Performance of CSOP Alternatives

South Florida Ecosystem Restoration Task Force

May 10, 2005
West Palm Beach, FL

Number of Weeks High/Low Water Depth Criteria Exceeded

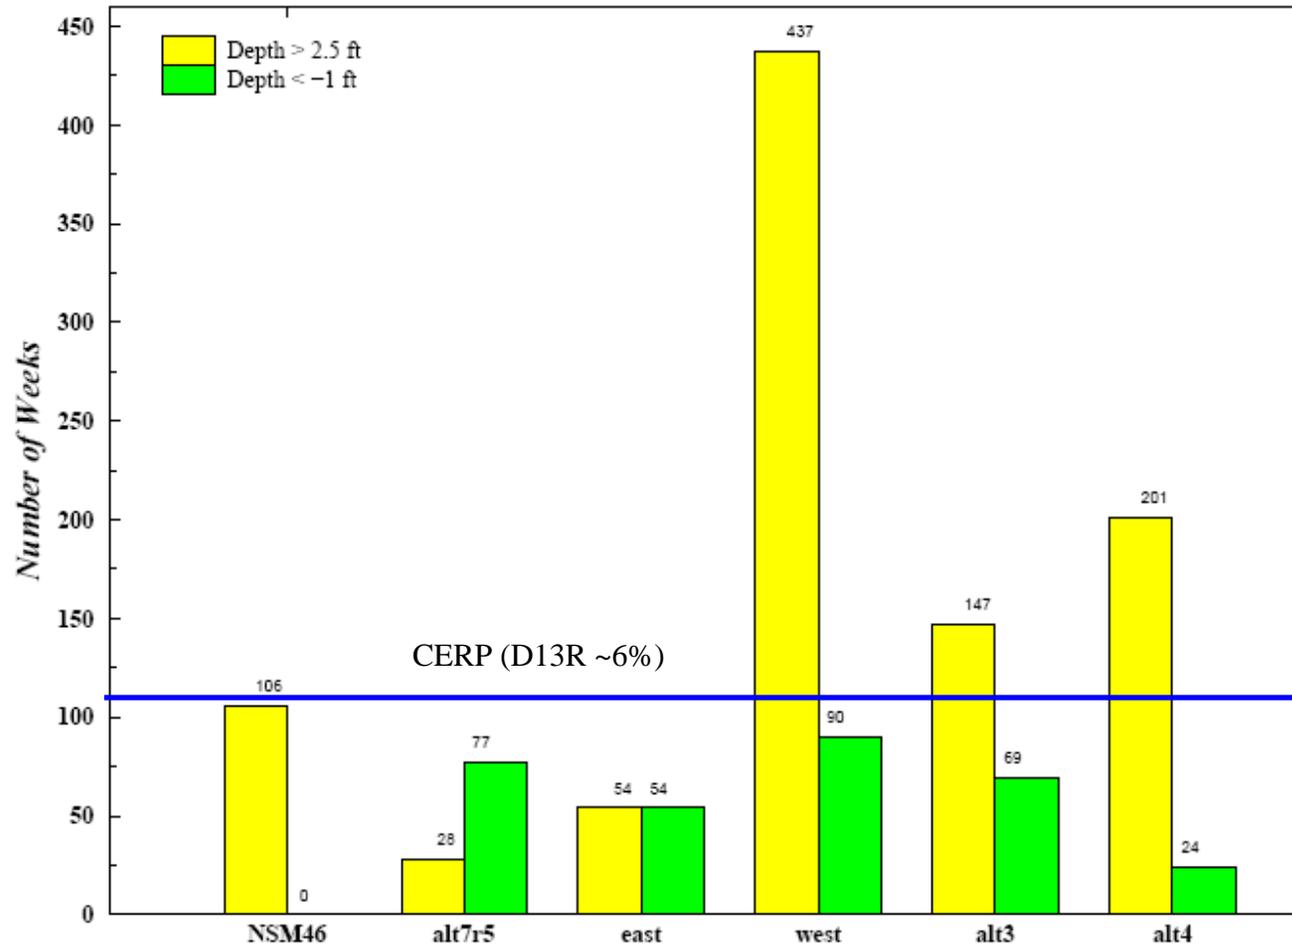
WCA-3B Water Levels

- Depths would be more harmful to tree islands than those authorized with CERP
- Additional seepage would exceed S-356's capacity to return to ENP
- Increased undesirable flows to Florida Bay would result from G-211 openings

- Alternatives which result in less than 112 weeks (6% of the time) of WCA-3B depths greater than 2.5 feet will protect tree islands in southeastern WCA-3B.
- Alternatives with average annual deliveries to Shark Slough substantively greater than the existing flow but less than CERP.
